# Complete Monograph

## **2024 GROUP A PROPOSED CHANGES TO THE I-CODES**

Committee Action Hearings (CAH #2)  
October 23 - 31, 2024  
Long Beach Convention Center  
Long Beach, CA

Figure 1. Detached accessory structures condition in 2024 IWUIC Scope.

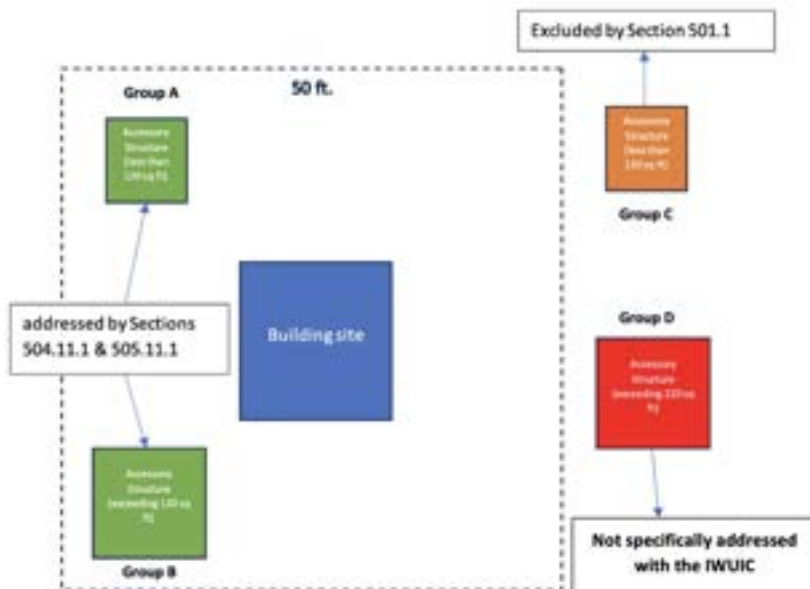
**Reason:** Based on the current language, detached accessory structures can essentially be categorized into four groups. These groups are illustrated in Figure 1:

- Group A: Detached accessory structures with a floor area of 120 sq ft and less, located less than 50 feet of the primary structure.
- Group B: Detached accessory structures with a floor area greater than 120 sq ft, located less than 50 feet of the primary structure.
- Group C: Detached accessory structures with a floor area of 120 sq ft and less, located 50 feet or more from the primary structure.
- Group D: Detached accessory structures with a floor area greater than 120 sq ft, located at 50 feet or more from the primary structure.

To address this issue, the proposed language recommends exempting all detached accessory structures located more than 50 feet away from a habitable building from the scope of IWUIC. This suggestion is supported by the findings of structure separation experiments conducted by the IBHS and NIST. These experiments indicate that when the separation distance between structures exceeds 50 feet, the risk of conflagration and structure ignition is significantly lower [1-3]. Chapter 7A of the California Building Code also includes similar requirements in Section 710A.3 (Figure 3) and this change will align these two codes from this perspective [4].
